TECHNICAL BULLETIN

Product : System 21 Passenger Lifts

Subject : Changes to Mirror Trim Details

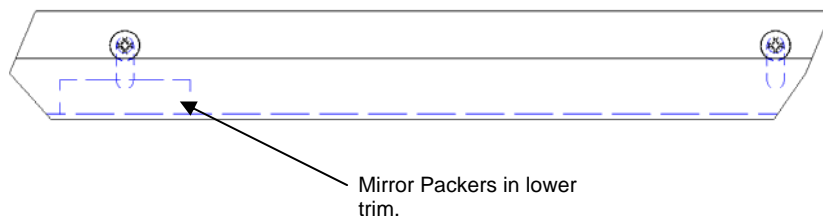
The fixing holes on all mirror trims have been replaced with a vertical slot to enable the top trim to be pulled down for a closer fit on the mirror. This feature has been introduced for traction lifts where the mirror can jump if the safety gear engages in the upward direction. The mirror trims should now be fitted as follows:

Fit the upper trim with the screws positioned at the bottom of the slot. The screws should then be fastened while leaving them just loose enough to allow the trim to be pulled down when the mirror is fitted.

Fit the lower trim containing the packers with the screws positioned at the top of the slot and fasten the screws.

The mirror may now be fitted and the top trim pulled down.
